ADDENDUM NO. 18

**Westfield Washington School Corporation
Centennial Road Reconstruction
Bid Package 05
17707 Centennial Road,
Westfield, IN. 46074**

ADDENDUM

PROJECT: Westfield Middle School – West

Z:\2024\240787-CONTEXT DESIGN TRAFFIC SIGNAL, SR 32-CENTENNIAL RD PH5 1DWS\CENTENNIAL PLAN SET\240787-TYP CENTENNIAL.DWG

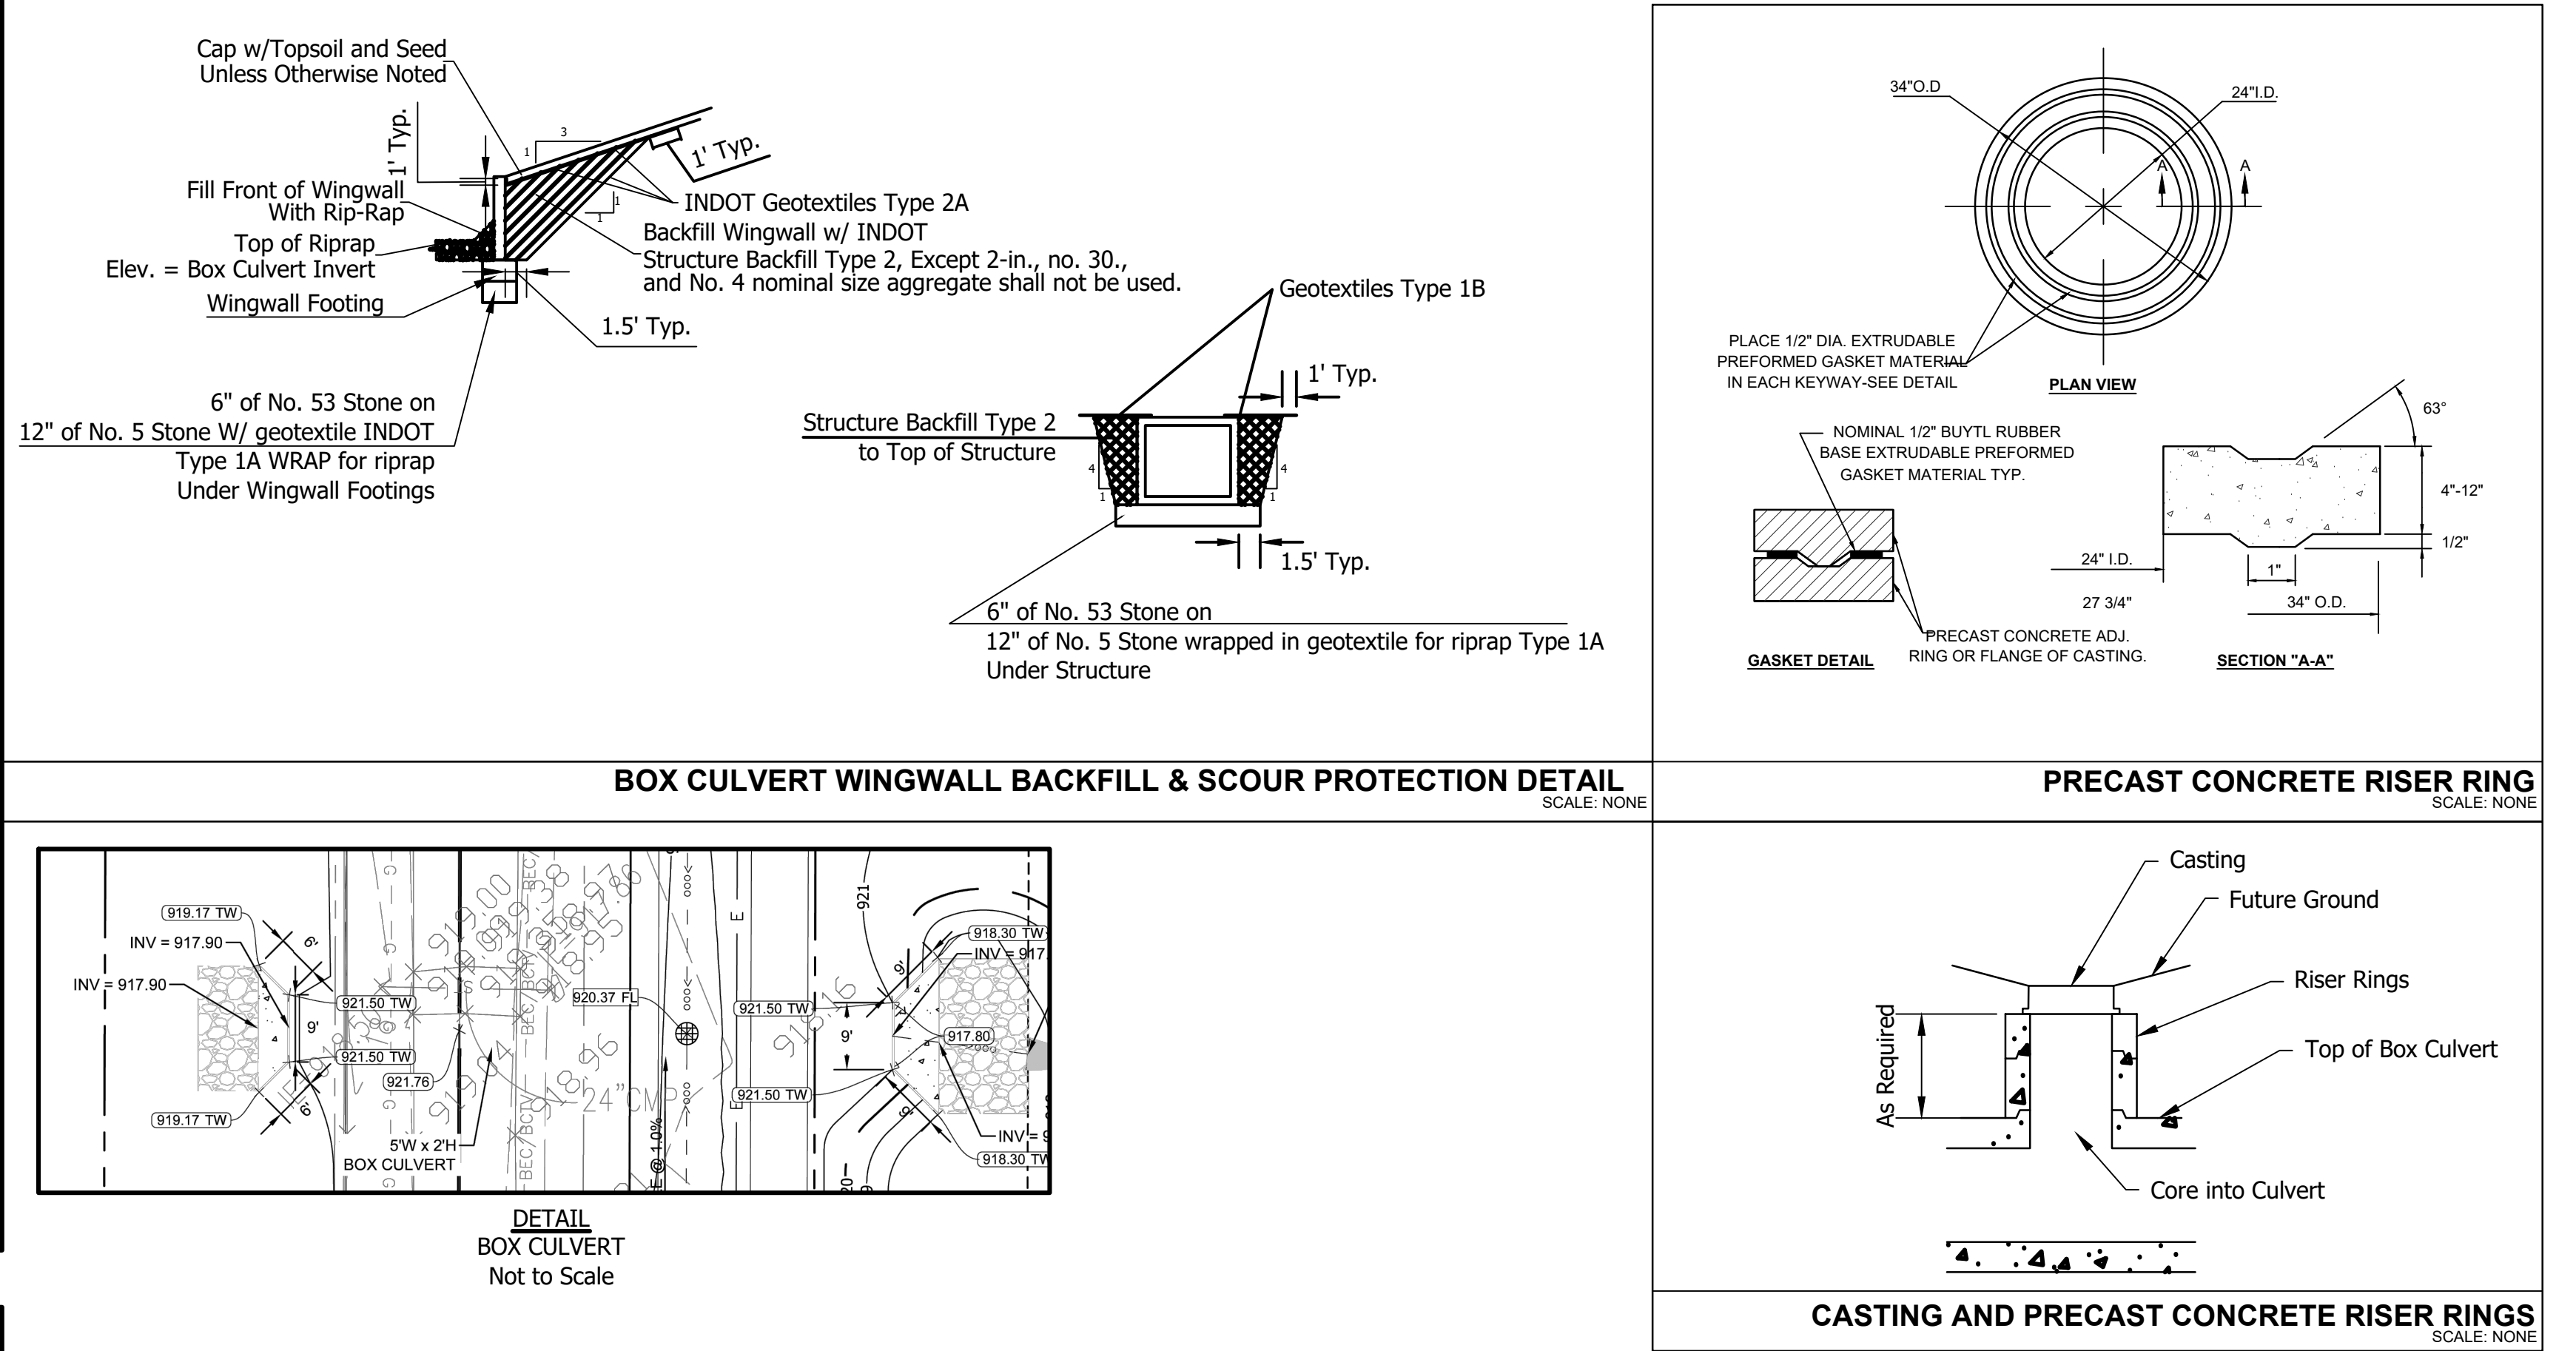
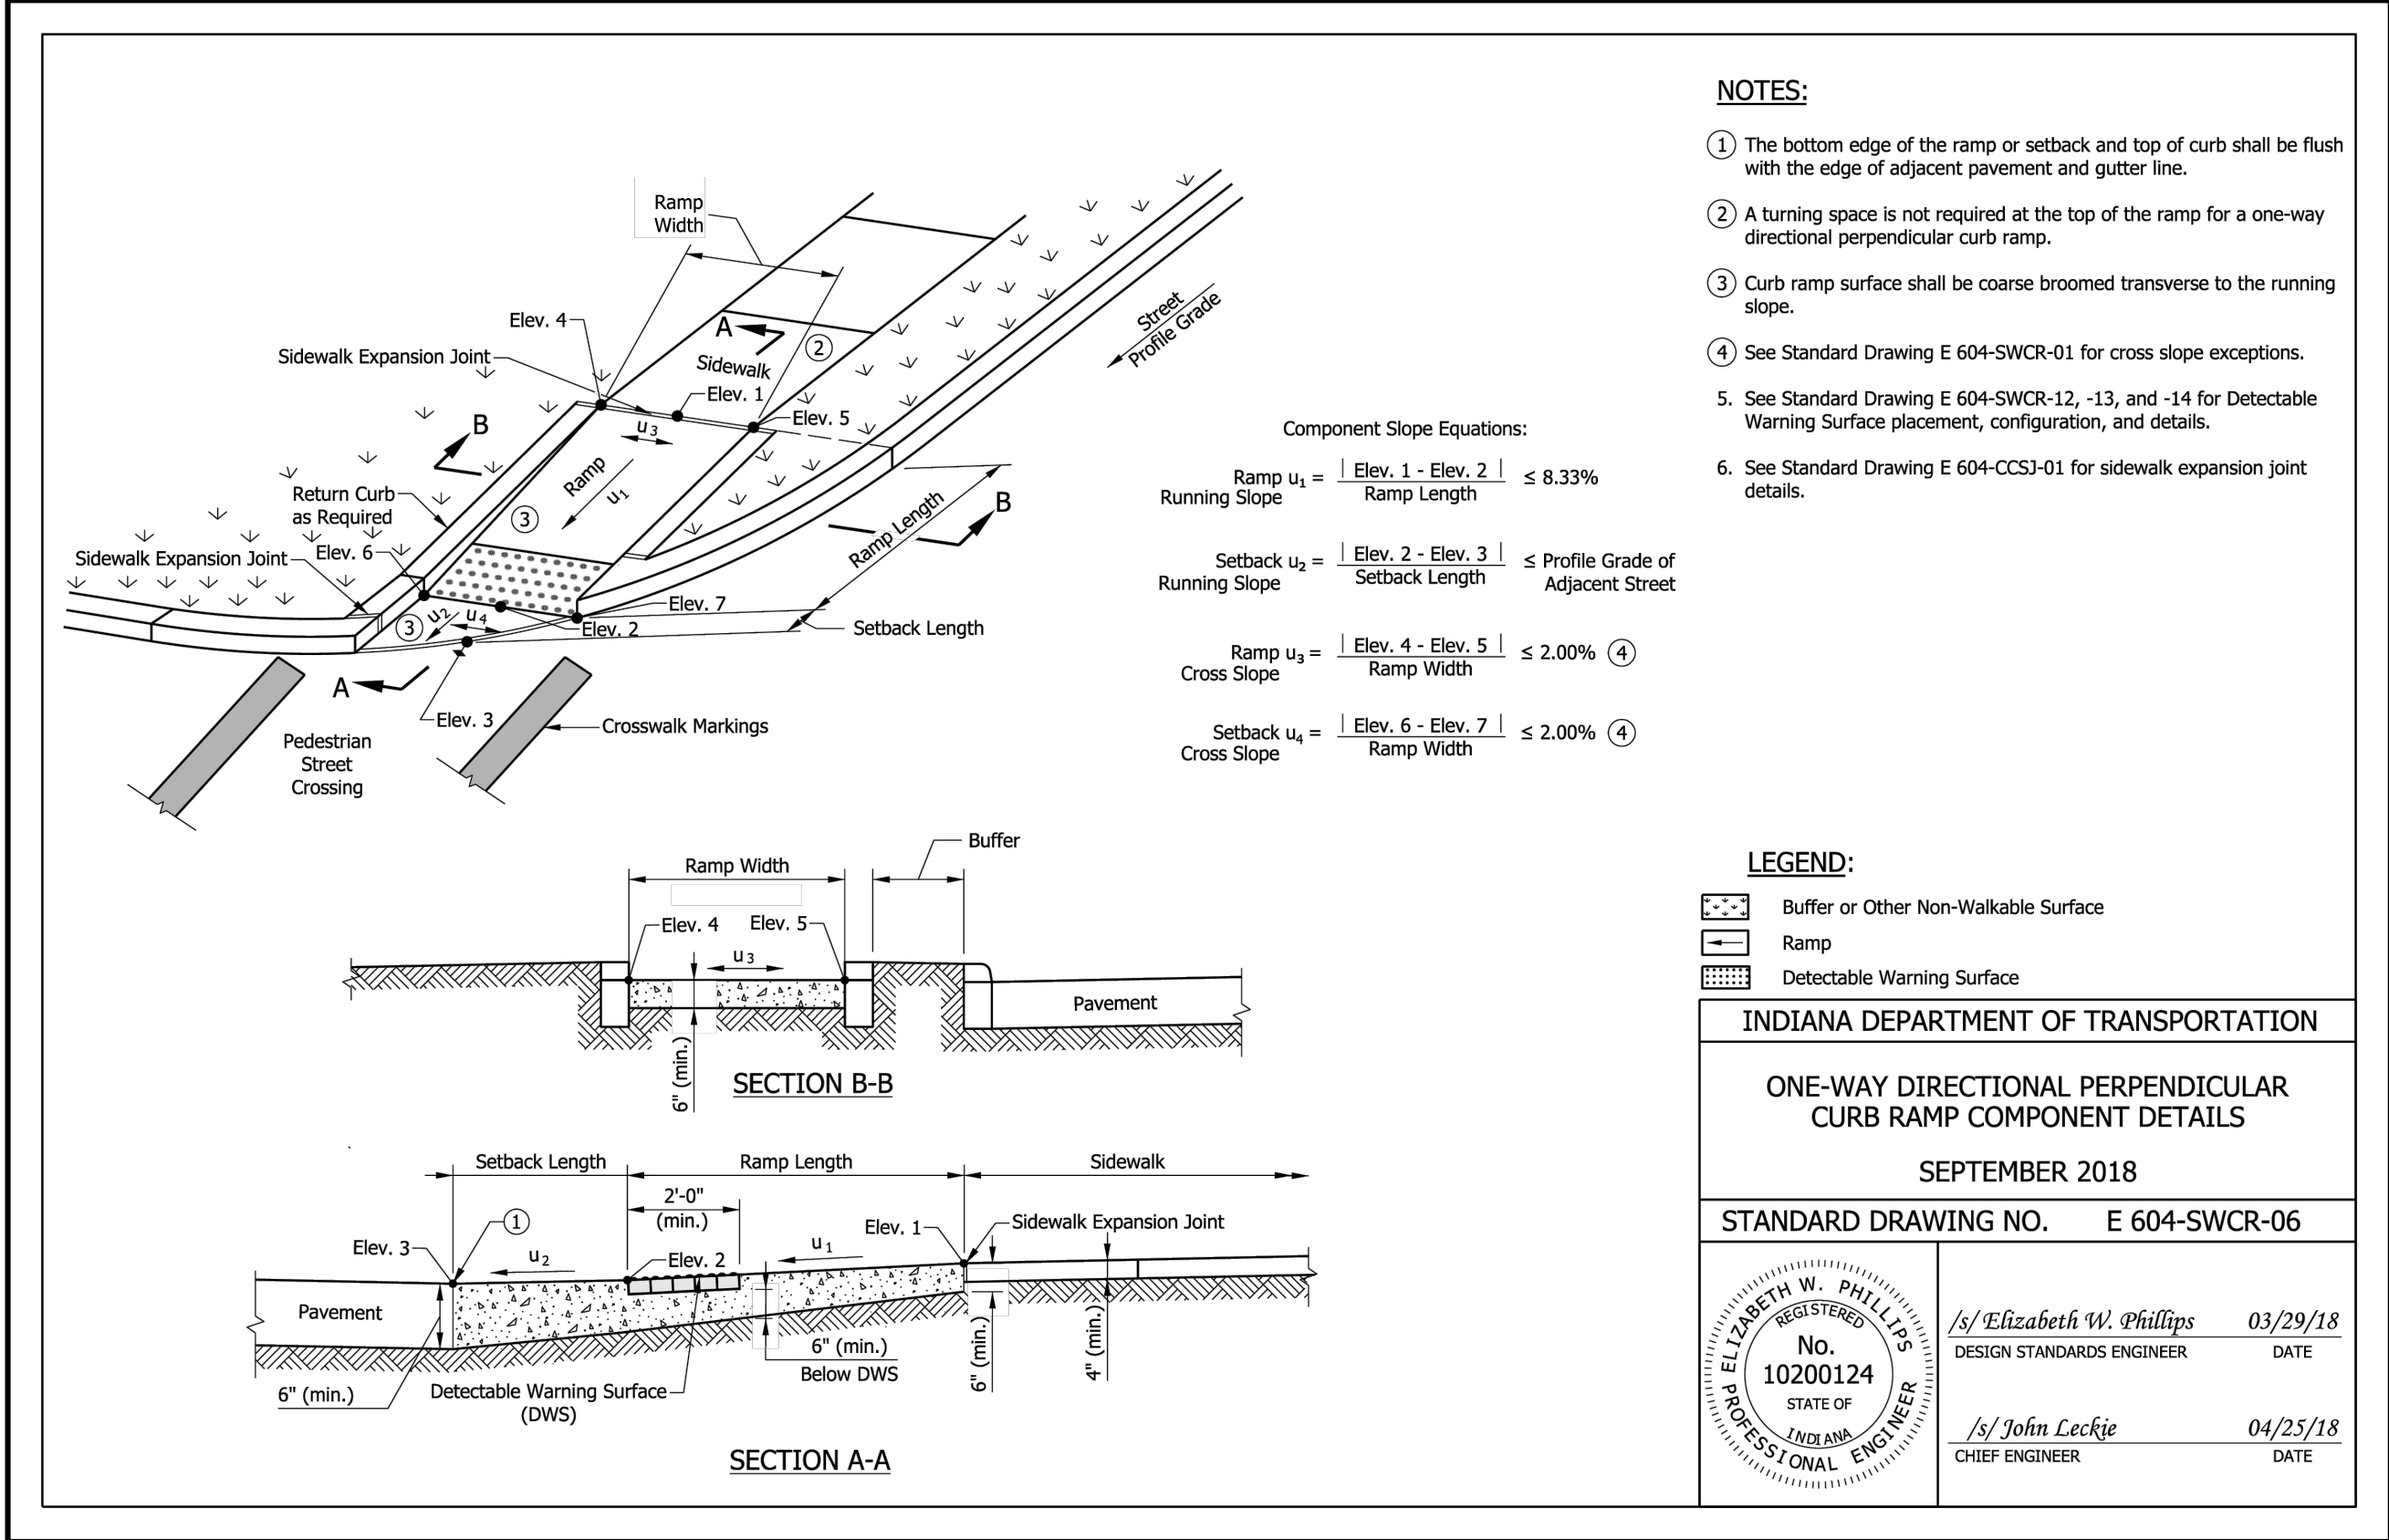
REVISIONS	
DATE	ITEM
Oct 2, 2025	Updated Str. 11A, Added detail notes to box culvert and casting

CROSS SECTIONS
LINE "PR-B"

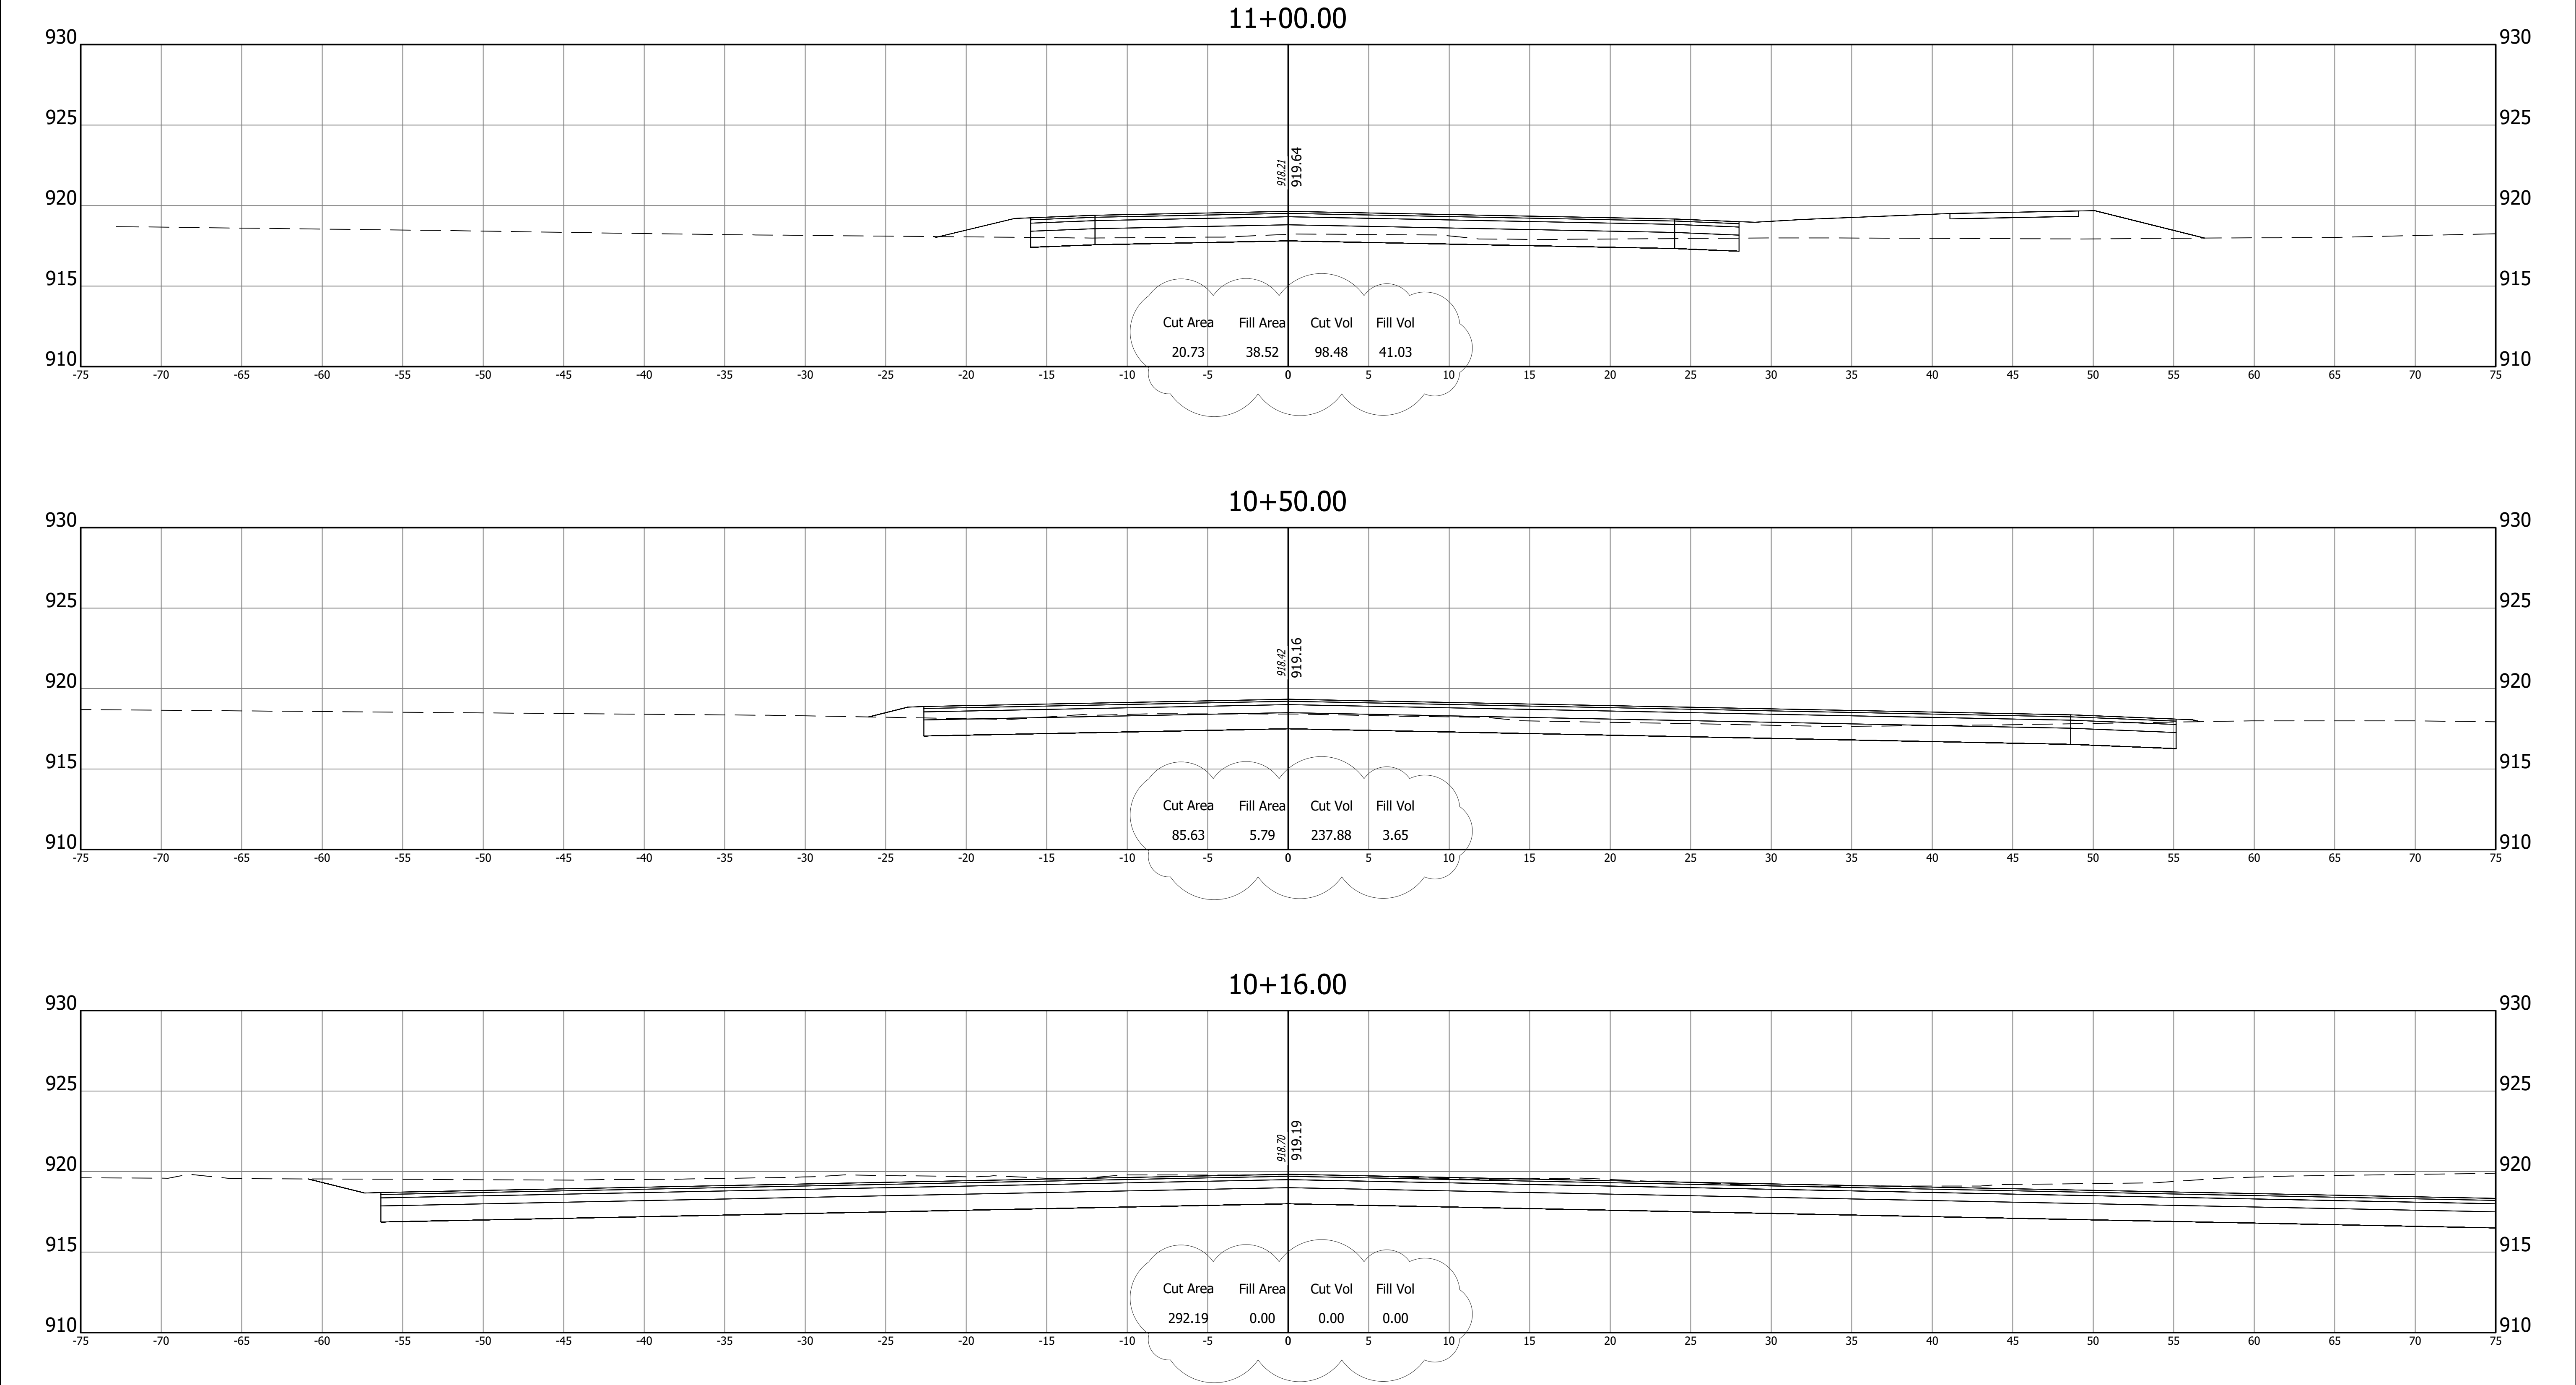
REVISIONS	
DATE	ITEM
Oct 2, 2025	Updated Earthwork
